A d d e n d u m

Iowa Department of Transportation
Office of Contracts

B.O.	Proposal ID	Proposal Work Type	County	Project Number	Addendum
103	59-0652-020	PCC OVERLAY - UNBONDED	LUCAS	NHSN-034-6(88)--2R-59 NHSX-065-2(20)--3H-59 STPN-014-1(12)--2J-93	15OCT103.A04

B.1

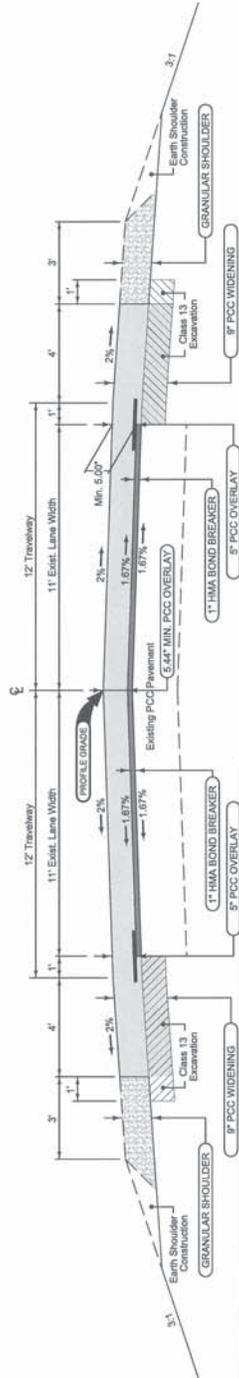
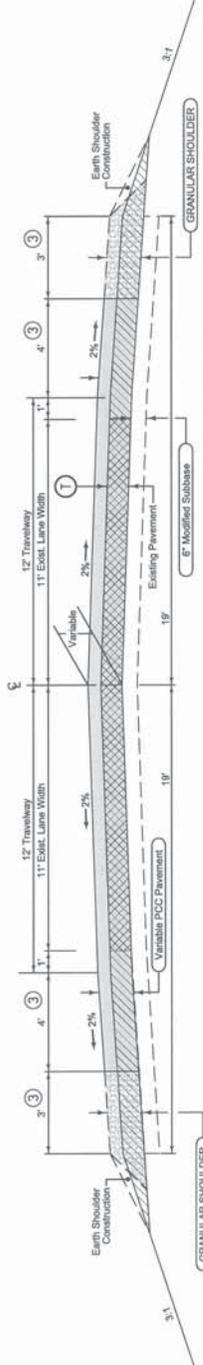
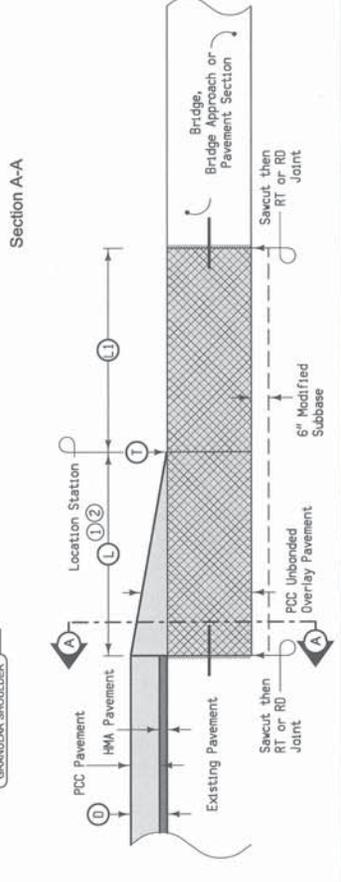
Note changes on plan sheet B.1:

Typical Overlay:

- Shoulder slope changes from 4% to 2%.
- Class 13 CY column values changed to reflect slope change.

Typical 7307 M:

- Shoulder slope changes from 4% to **2%**.
- Class 13 CY column values changed to reflect slope change.

SHEET NUMBER B.3

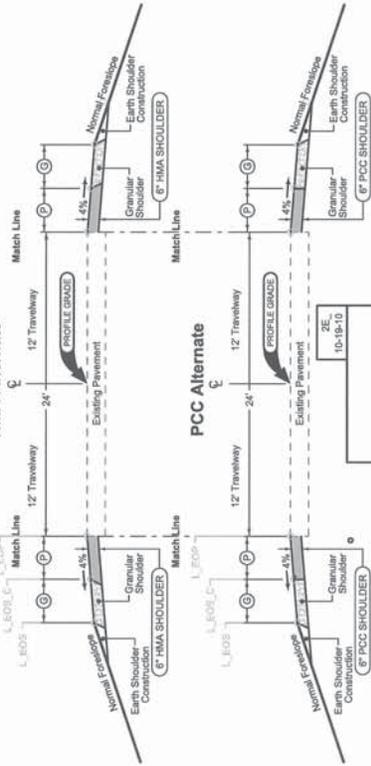
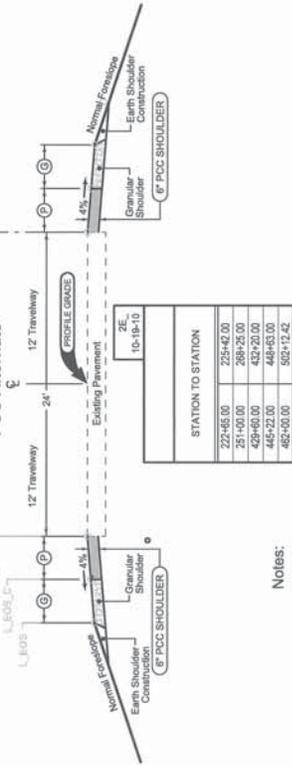
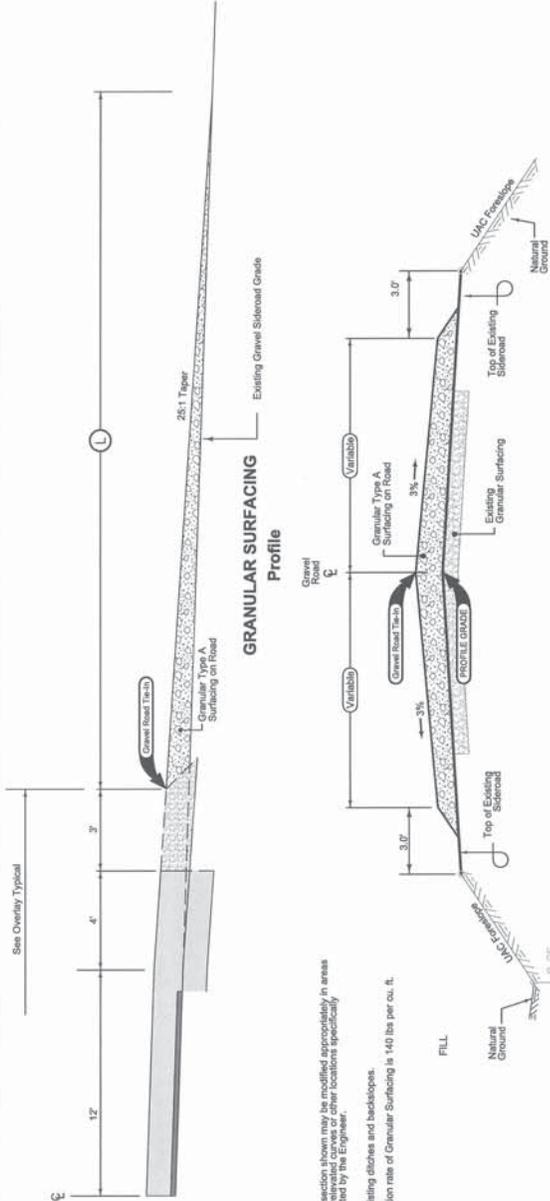
Note changes on plan sheet B.3:

Typical Shldr:

- PCC Shoulder Jointing Note: Longitudinal joint: BT-5 with tie bars spaced at 42” centers. Transverse joint: C matching existing pavement transverse

PAVED SHOULDER AT GUARDRAIL

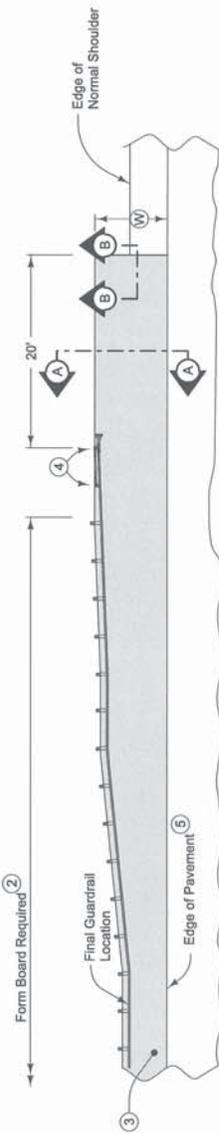
Note changes on plan sheet B.5:

Typical 7156:

- Changed circle note 5 and added: ‘BT-5’ joint with tie bars spaced at 42” centers.
